### **BOARD ACTION REPORT – APPEALABLE ITEM**

**Project Name:** Abbey Delray  
**Project Location:** 2000 Lowson Boulevard  
**Request:** Class IV Site Plan, Landscape Plan, and Architectural Elevations.

### ---STAFF REPORT---

**ITEM:** Abbey Delray – Class IV Site Plan, Landscape Plan and Architectural Elevations associated with renovation and expansion of an existing building to add 48 assisted living and 30 memory care units, parking lot reconfiguration, landscaping modifications.

# A-210

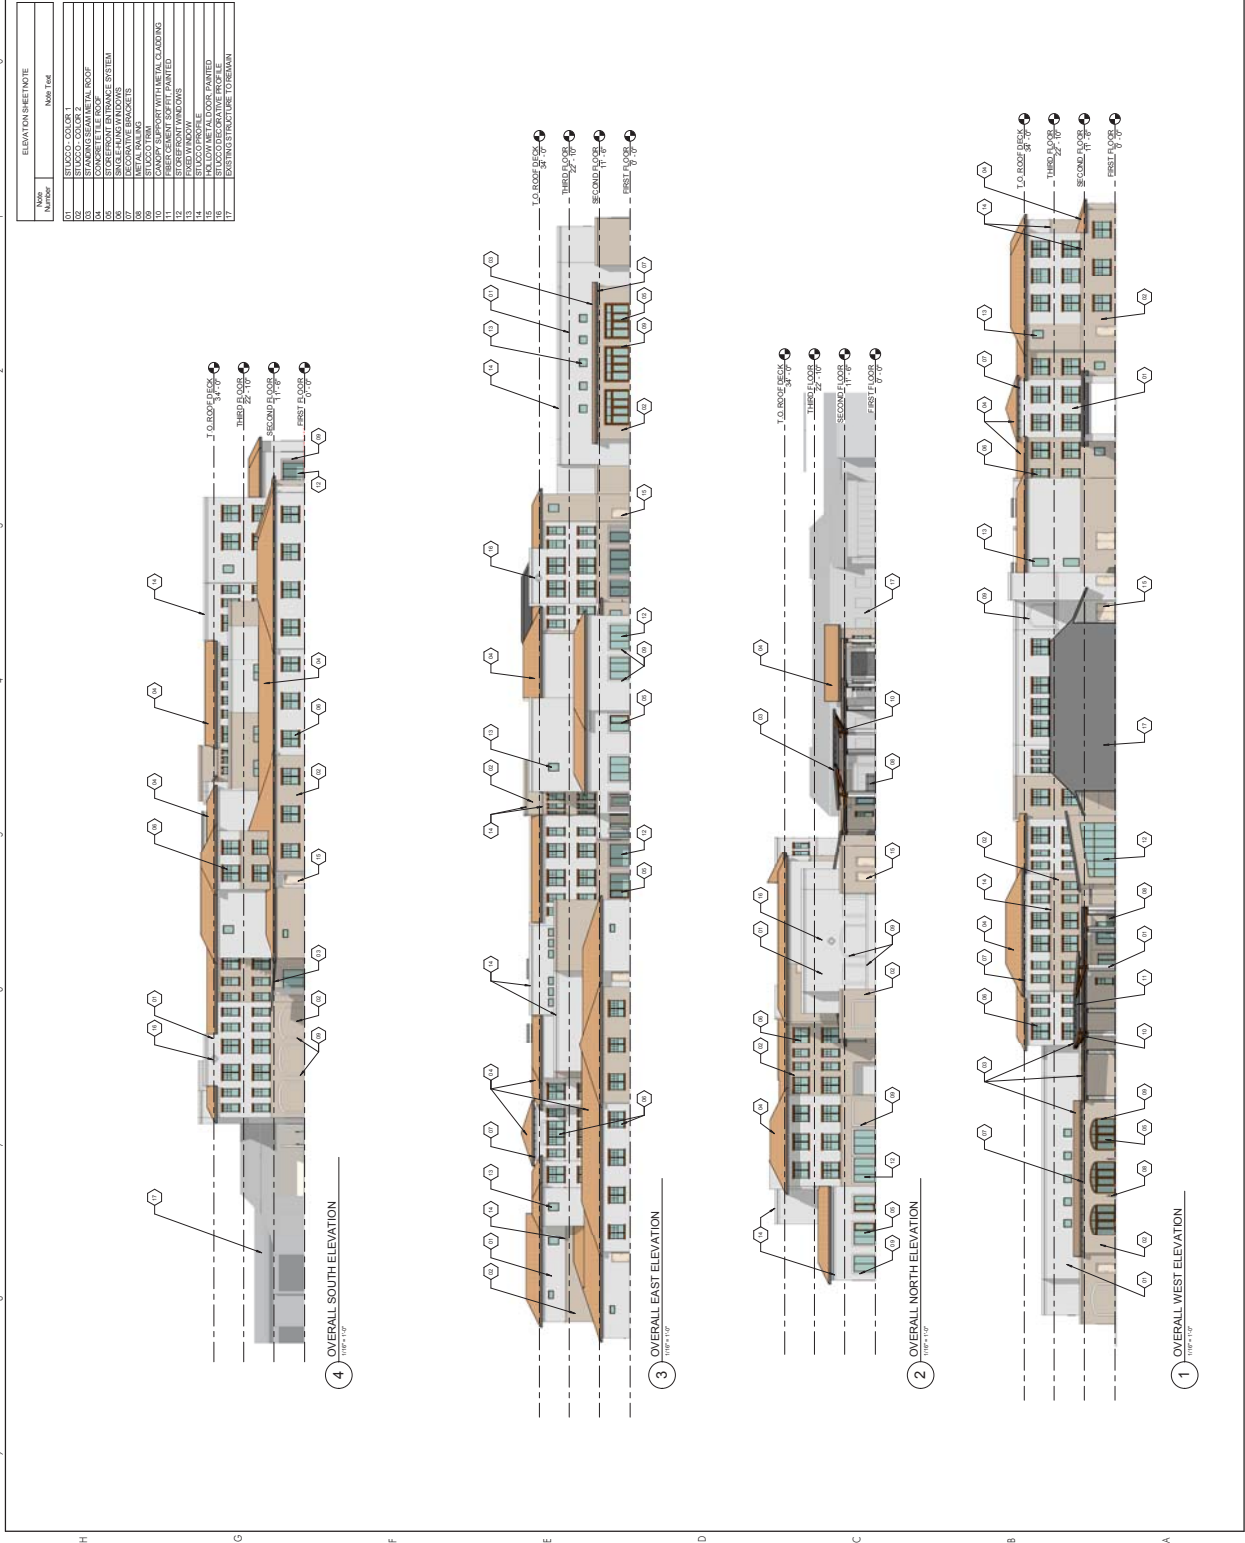
1. Prior to site plan certification, provide revised sheets for A.2.11 and A.2.12 A that depict the roof line, massing and detail shown on Sheet A-210.
2. The Roof Plan on Sheet A.141 is corrected to replace the hipped roof above an entry in the southwest portion of the building to reflect a flat roof with a parapet, as shown on the Elevations on Sheet A-210.

1. Prior to site plan certification, provide revised sheets for A.2.11 and A2.12 A that depict the roof line, massing and detail shown on Sheet A-210.
2. The Roof Plan on Sheet A.141 is corrected to replace the hipped roof above an entry in the southwest portion of the building to reflect a flat roof with a parapet, as shown on the Elevations on Sheet A-210.
